## SERVICE BULLETIN

HEATING &  
AIR CONDITIONING  
REFERENCE \_\_\_\_\_  
NUMBER 008  
DATE 11-10-89  
MODEL 1990 4Runner

### INTERFERENCE BETWEEN A/C CONDENSER AND FRONT CROSSMEMBER GUSSET

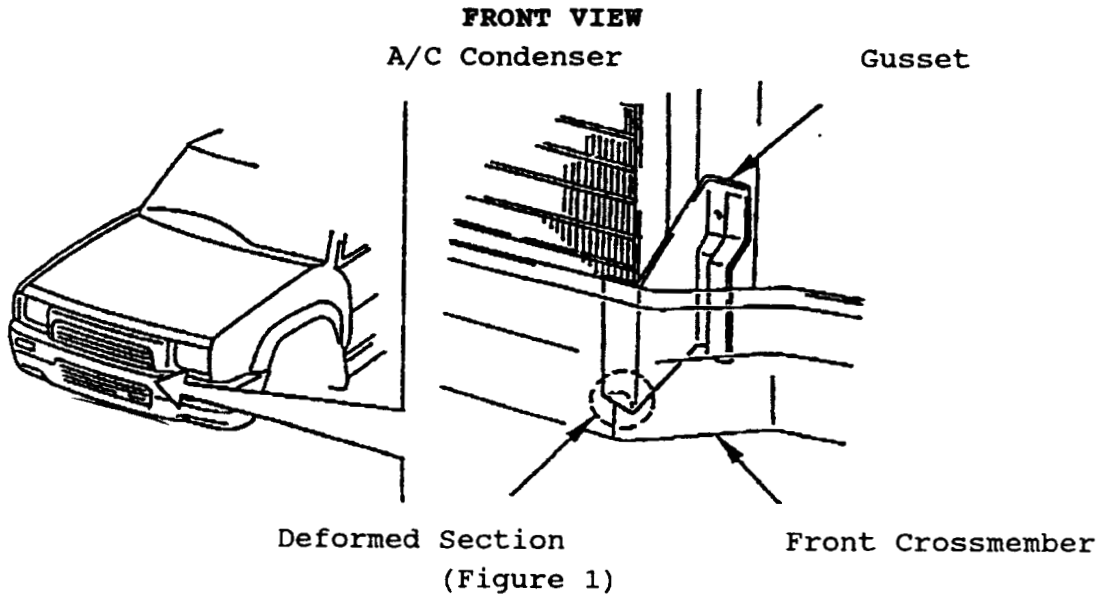
Interference between the front lower left section of the A/C Condenser and the left front Crossmember Gusset on 1990 4Runner may result in damage to the A/C Condenser. This damage may occur during installation or afterwards in service.

- 1) Check the left front Crossmember Gusset for deformation (see Figure 1).
- 2) If the left front Crossmember Gusset is deformed, use the **REPAIR PROCEDURE** (see Figure 2).

- 1) After removing the A/C Condenser, place a piece of cardboard in front of the Radiator to protect it from damage.
- 2) Place a blunt Chisel on the deformed Gusset section and hammer to form the Gusset into the correct shape (see Figure 2).
